DEVELOPMENT ASSESSMENT PANEL REPORT	
<b>Application No.</b>	REV/2025/0003
<b>Address</b>	95 Australia Street CAMPERDOWN
<b>Proposal</b>	Section 8.2 Review of DA/2024/0700 determined on 11/02/2025, for alterations and additions to an existing semi-detached dwelling, including partial demolition of existing structures and construction of ground and first floor additions, review involves amended plans.
<b>Date of Lodgement</b>	20 March 2025
<b>Applicant</b>	Andrew Ireland
<b>Owner</b>	Merilyn Ireland
<b>Number of Submissions</b>	Three
<b>Cost of works</b>	\$334,263.00
<b>Reason for determination at Planning Panel</b>	Review of determination made by the local planning panel
<b>Key Considerations</b>	Streetscape impacts, bulk and scale, neighbouring amenity.
<b>Recommendation</b>	Deferred Commencement Approval
<b>Attachment A</b>	Recommended conditions of consent
<b>Attachment B</b>	Plans of proposed development

<b>Attachment C</b>	Previously refused plans of proposed development

Figure 5: excerpt of DA25 D Sections, showing connection of proposed addition and increased height to rear of site.

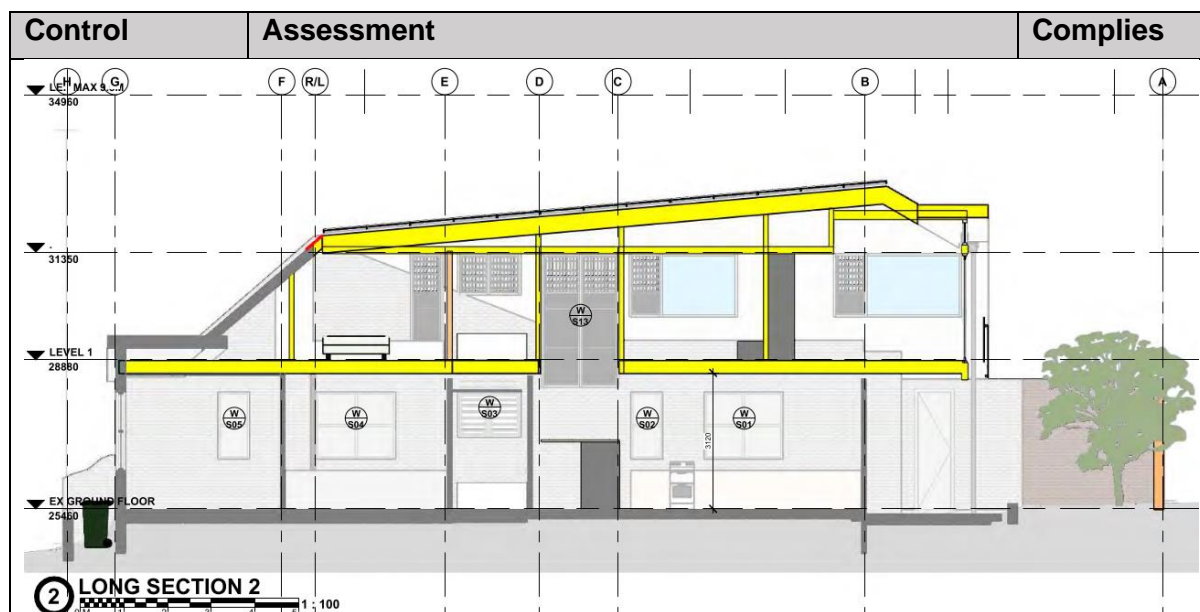
The proposed connection of the addition forward of the ridgeline and the increase in height results in a bulk and mass that is unacceptable for the streetscape, and lanescape. The additions are at odds with the original building and overwhelm the existing built form. The additions fail to be subordinate in their current form.

Further, the design of the proposal results in visual impacts (v). Accordingly, the recommendation includes a deferred commencement condition to alter the connection of the addition to the original roof, being set behind and below the original ridge, extending up behind the ridgeline, changes to the proposed roof pitch, and lowering of the overall height of the development via changes to internal levels.

- d. The rear setback to the first floor addition must not be less than 4500mm.
- e. The front dormer window is to be deleted.
- f. The internal layout of the first floor may be redesigned to accommodate a re-planning of bedroom 1 and adjacent bathroom/s to allow the bedroom access to the larger windows and a bathroom to be incorporated in the area having the lower floor to ceiling heights beneath the roof ridge.
